1.1. Viewpack FOR 9/24/20

8. Cannonbury Ln Hold 1 08-1565					
	7 Cannonbury Lane	New cabana	74/29	Workshop APD	
Voting	Pohl, Coombs, McLaughlin, Camp, Oliver				
Alternates	Welch, Dutra				
Recused	None				
Documentation	Architectural elevation plans, site plan, photos, and advisory comments				
Representing	Michael Luft-Weissberg, Workshop APD				
Public	None				
Concerns (6:13)	<p>Luft-Weissberg – Presented project.</p> <p>Camp – The gable pitch should relate to the main house or the garage.</p> <p>McLaughlin – West elevation, asked what is right of the door (outdoor shower). North elevation, the opening in the roof over the shower is inappropriate.</p> <p>Oliver – No concerns.</p> <p>Coombs – No concerns as long as the roof pitch masses the house.</p>				
Motion	Motion to Approve as submitted. (Coombs)				
Roll-call Vote	Carried 4-1//Oliver, Camp, Coombs, and Pohl-aye; McLaughlin-nay		Certificate #	HDC2020-08-1565

10. Cannonbury Ln Hold 1 08-1569					
	4 Sleetwing Circle	New cabana	74/23	Workshop APD	
Voting	Pohl, Coombs, McLaughlin, Camp, Dutra				
Alternates	Welch				
Recused	(Oliver stepped out)				
Documentation	Architectural elevation plans, site plan, photos, and adviso

HDC.2

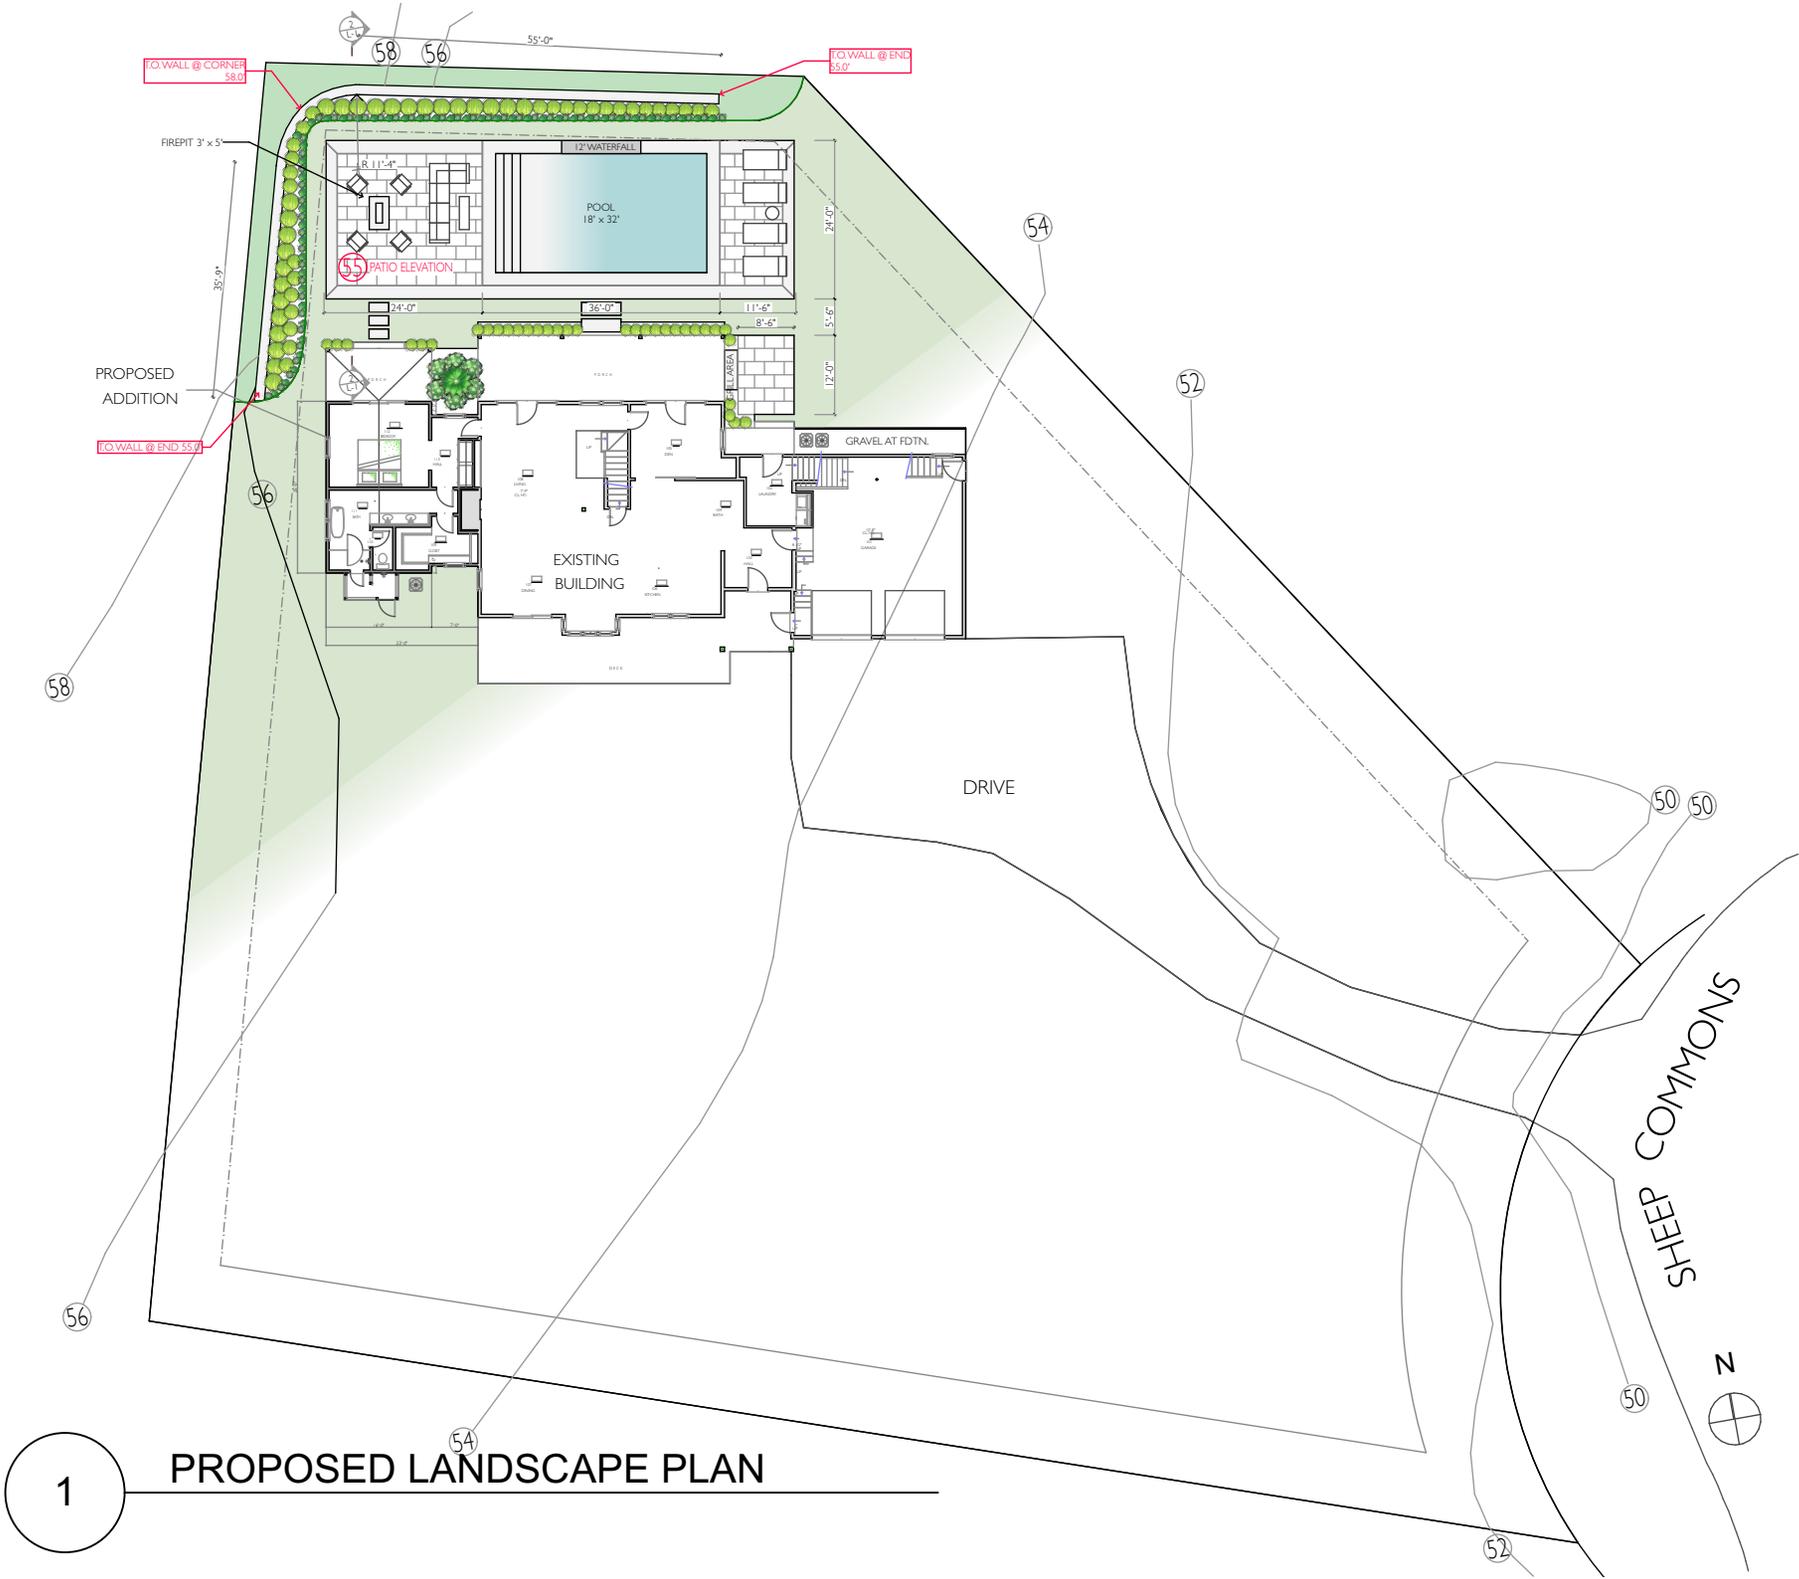
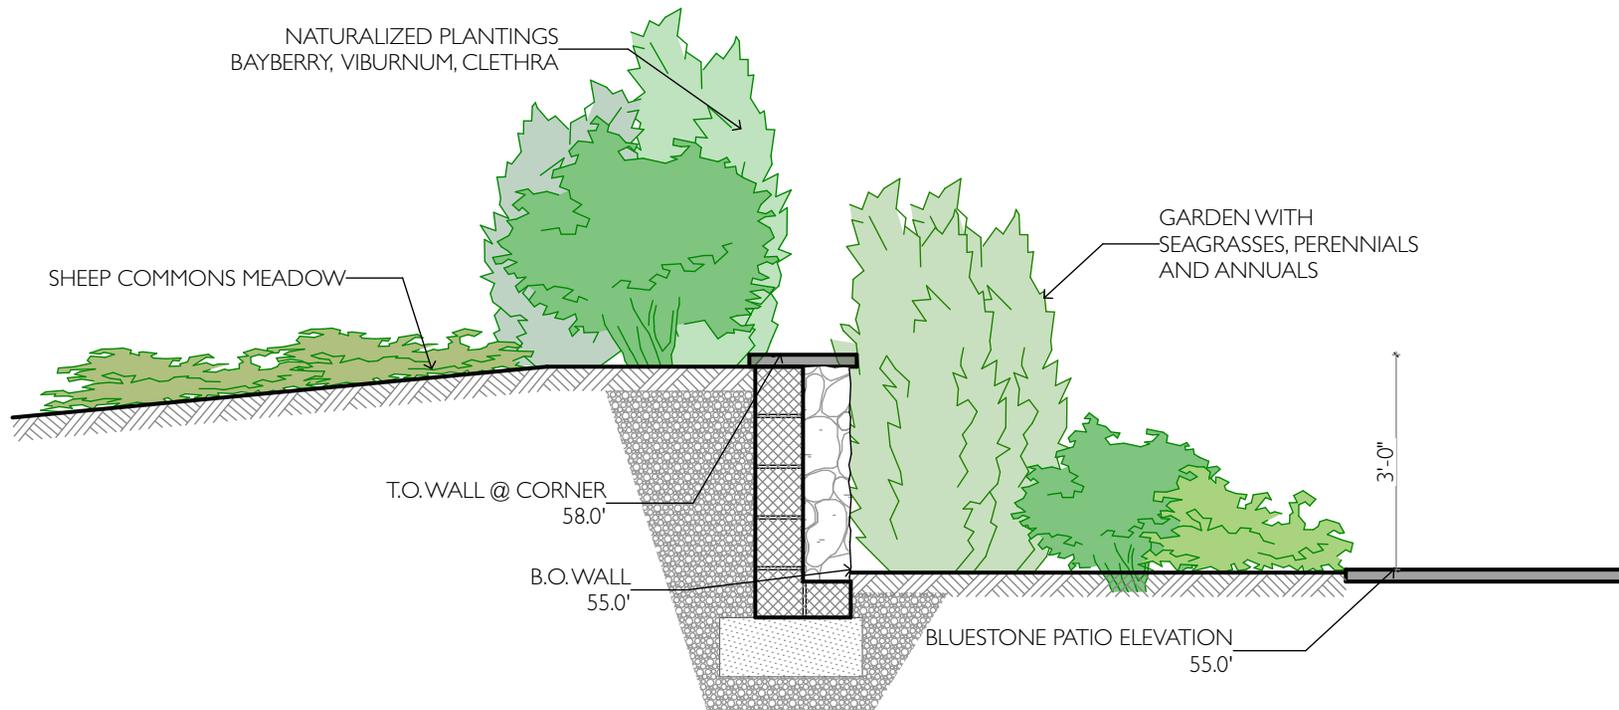
Roll-call Vote	Carried unanimously//Welch, Coombs, Oliver, Camp, and Pohl-aye			Certificate # HDC2020-08-1544	
3.	Chris O’Connell 08-1556	10 Sheep Commons	Pool & retaining walls	54-274	Atlantic Landscaping
Voting	Pohl, Coombs, Camp, Oliver, Welch				
Alternates	None				
Recused	None				
Documentation	Architectural elevation plans, site plan, and photos.				
Representing	Lindsay Congleton, Atlantic Landscaping Inc.				
Public	None				
Concerns (1:35)	Congleton – Presented project; grade will be “sloping to the top of the wall.” Oliver – This is probably fine; however, would like more information delineating the details; it doesn’t say how high the walls are or how far the pool is sunken or anything. In the future we need to have all the information; there is nothing here for the inspector to reference. Welch – The topography of the Land Bank area is such that the back yard is within that contour; the pool is parallel to the contour that would hide it. This might be visible from the Land Bank property so would like to view this. Wants the information on the wall as well. Coombs – Agrees with Mr. Welch. Would like to see an elevation of the waterfall with its height. Camp – Wants to know what the vegetation will be in front of the stone wall; wants the stone softened from the outside with a natural vegetation. Pohl – Doesn’t understand what is meant by “sloping to the top of the wall?”; otherwise the wall is 4 feet.

Motion	Motion to View and Hold for revisions and more information on topography and a cut through from the walls to pool and planting plan. (Oliver)				
Roll-call Vote	Carried unanimously//Camp, Coombs, Welch, Oliver, and Pohl-aye			Certificate #

1 Site Plan
1" = 20'-0"

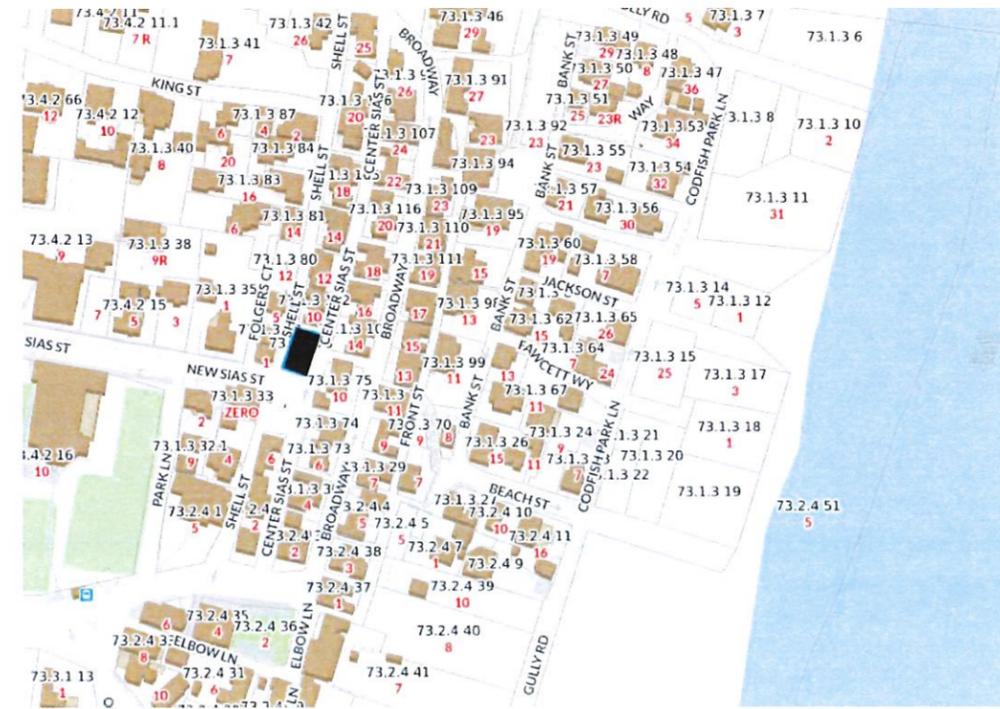
17. Mary O’Connell 08-1508 8 Center Street (Sias) Rev. 12-0352: relocate A/C cond 73.1.3/76 Concept Design
 Voting Pohl, Coombs, Oliver, Welch
 Alternates (Camp still out.)
 Recused None
 Documentation Architectural elevation plans, site plan, photos, historic documentation, and advisory comments.
 Representing T.J. Watterson, Concept Design
 Public None
 Concerns (7:20) **Watterson** – Presented project; to be enclosed in natural-to-weather, cedar lattice.
Backus – Circa 1790. Read SAB comments: A/C might be noisy and visible to visitors in the square; previous location preferred; want to know about screening.
Coombs – Lattice screening has worked well on Shell Street; thinks this will work.
Welch – Given the location, he’d like a detailed drawing in the file showing the lattice enclosure from inside the fence; some of these units need a ground clearance of 10 to 12 inches.
Oliver – She wants to view this.
